MEMORANDUM

TO: Stephanie Stoddard, RCRA Permitting Group
THROUGH: Steve Alexander, Technical Section Supervisor *SA*
FROM: Ron Kern, Technical Program *RK*
DATE: March 31, 1993
SUBJECT: **Background Soil Data Collection and Analysis for Methylene Chloride (MeCl) at Kirtland Air Force Base (KAFB) Battery Shop French Drain (FD), Albuquerque**

Sample Locations - ⊗

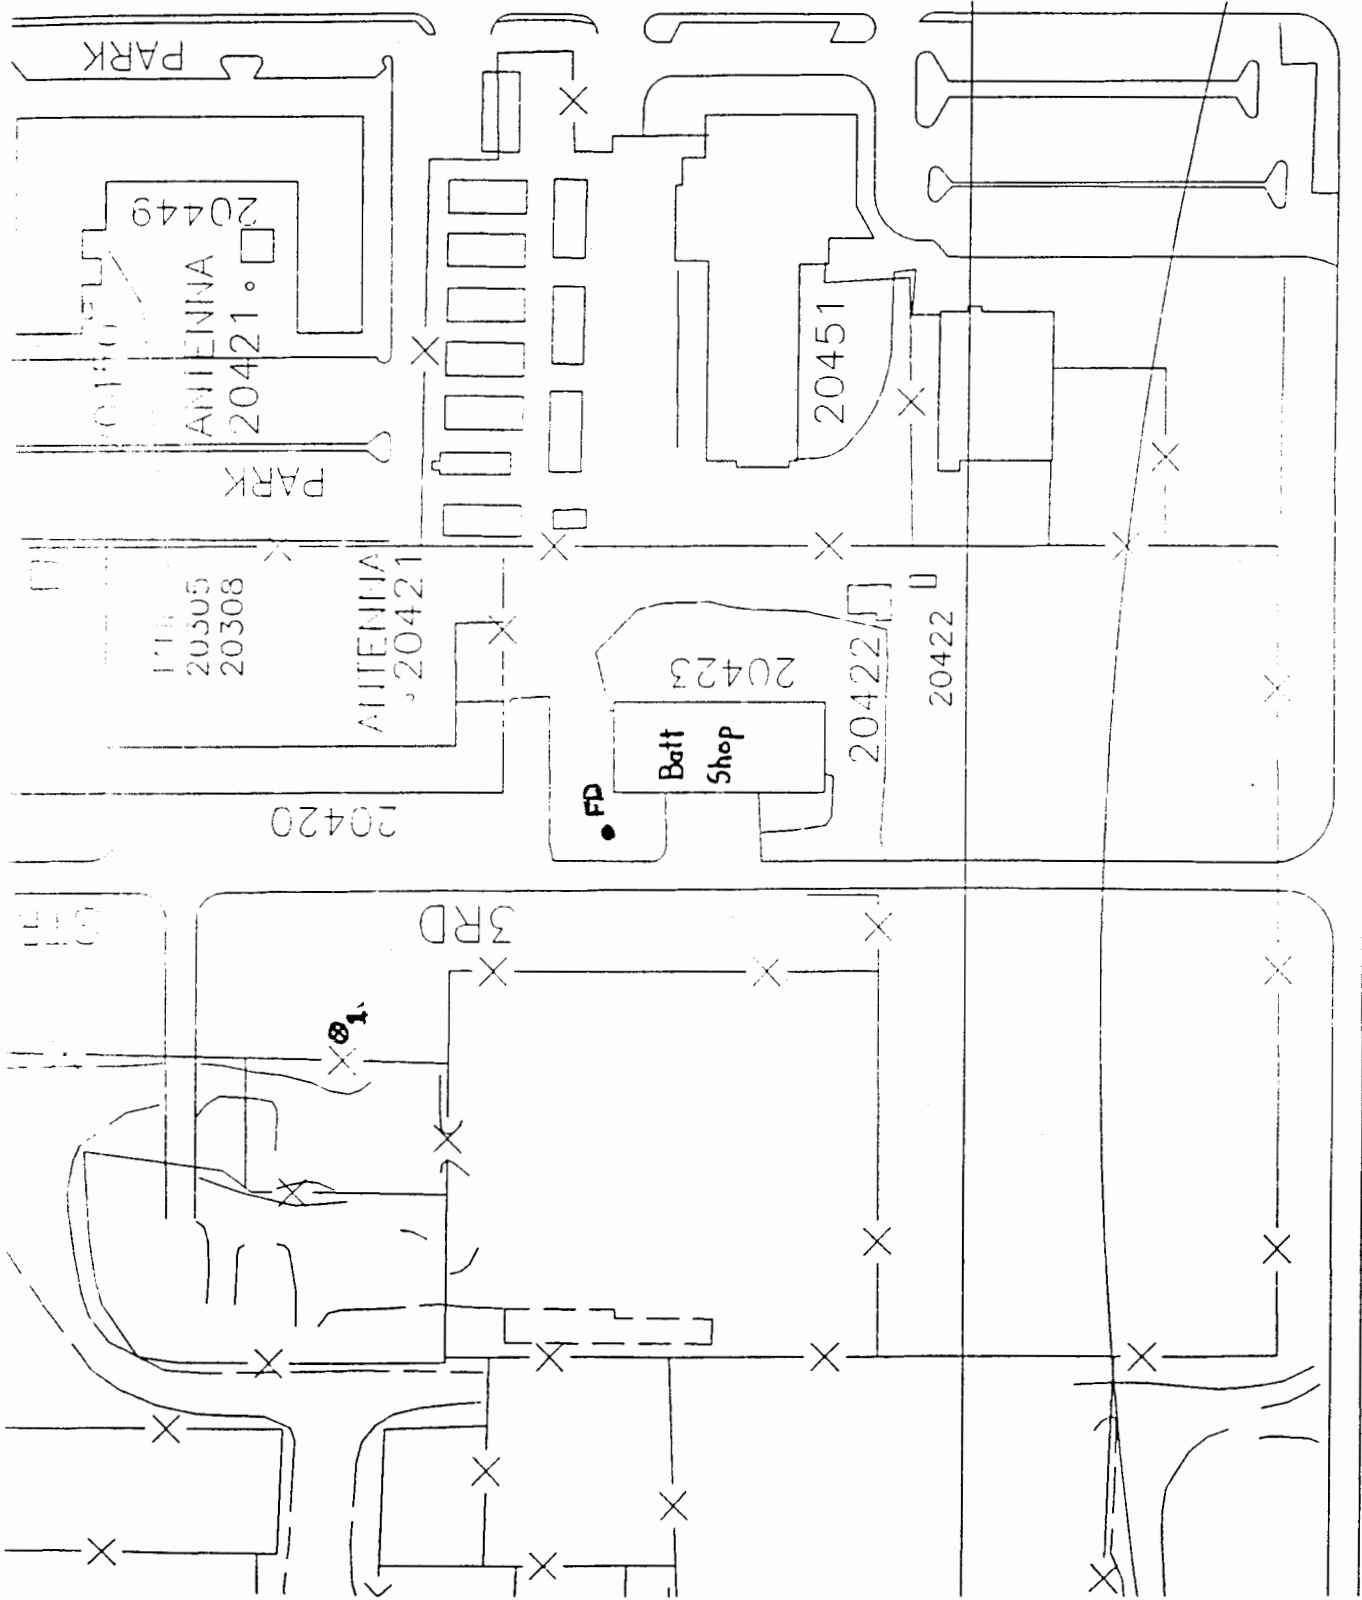
Three sample sites were selected and depicted on a simple sketch map by KAFB (attached). These appear to be within a horizontal distance of 250 to 600 feet from the FD; the map has no explanation of scale. These sample sites were selected to be outside the area of probable contamination from the FD and outside areas of other potential Pb contamination. Soil samples were proposed to be taken from a depth of three (3) feet.

4. In discussion with John Gould (Supervisor, Installation Restoration Program, KAFB) on March 26, 1993, sample sites 2 and 3 on the attached map were clarified and appear to be acceptable background sample sites. Site number 1 is unacceptable and should be located in an area outside of any probable contamination.

1. Three (3) background soil samples are acceptable, but this should be considered as a minimum number.
2. A depth of three (3) feet is unacceptable because the previous soil boring program (July, 1992), for which these background samples are to apply, took samples from a minimum depth of ten (10) feet. Background soil samples should be acquired from a depth of not less than ten (10) feet at all sample sites.
3. Background soil samples should be collected from the same USDA
